# Access Compliance Report

## Public Rights-of-Way

### (Curb Ramps)

Intersection ID: 4937	Main Street: CASTLEMAINE_DR	Cross Street: GRANARD_LN	Location: NE
ADA ID: 10471FB819A6	Ramp Type: Perp	Initial Pass/Fail: Fail	Overall Compliance: No
Codes/Mitigation Info/Possible Solution			Severity Score: 25
			Field Measurements/Component Compliance

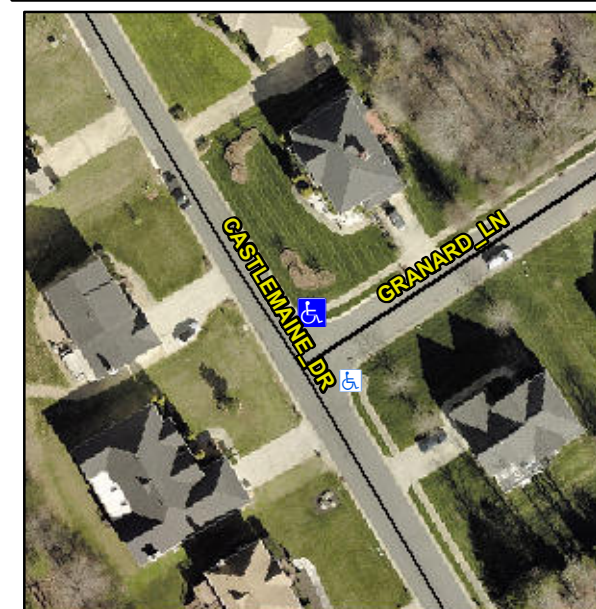
Compliance	Description	Data	Compliance	Description	Data
N/A	Ramp Length (in)	47.0	No	Ramp Slope (%)	11.2
Yes	Ramp Width (in)	59.0	No	Ramp XSlope (%)	5.1
N/A	Flare Type LT	N/A	N/A	Flare Type RT	N/A
N/A	Flare Slope LT (%)	N/A	N/A	Flare Slope RT (%)	N/A
N/A	Flare Traversable LT?	N/A	N/A	Flare Traversable RT?	N/A
N/A	Landing Length (in)	N/A	N/A	DWS Provided?	N/A
N/A	Landing Width (in)	N/A	N/A	DWS Contrast?	N/A
N/A	Landing Slope (%)	N/A	N/A	DWS Length (in)	N/A
N/A	Landing X Slope (%)	N/A	N/A	DWS Full Width?	N/A
N/A	Landing Curb? (Y/N)	N/A	N/A	DWS Offset (in)	N/A
N/A	Shared Landing?	N/A			
N/A	Gutter Ponding?	N/A	N/A	Gutter Slope (%)	N/A
N/A	Gutter Lip Ht (in)	N/A	N/A	Gutter X Slope (%)	N/A
N/A	Painted X Walk1?	No	N/A	Painted X Walk2?	N/A
	X Walk 1 Direction	To S		X Walk 2 Direction	N/A
N/A	X Walk 1 Width (in)	N/A	N/A	X Walk 2 Width (in)	N/A
	X Walk 1 Slope (%)	1.3		X Walk 2 Slope (%)	N/A
	X Walk 1 X Slope (%)	10.7		X Walk 2 X Slope (%)	N/A

N/A	Ramp inside XWalk1?	N/A	N/A	Ramp inside XWalk2?	N/A
	Road Slope (%)	N/A	N/A	Clear Space?	N/A
	Road X Slope (%)	N/A	N/A	Clear Space to XWalk (in)	N/A
N/A	Any Obstructions?	N/A	N/A	Storm Grate/Utility Hazard?	N/A
	Obstruction Type			Storm Grate/Utility Type	
		N/A			N/A
			Yes	Surface Condition? (G/P)	Good

Possible Solutions:

**Remove & Replace Entire Ramp.**

**R304.2.2, R304.5.3**
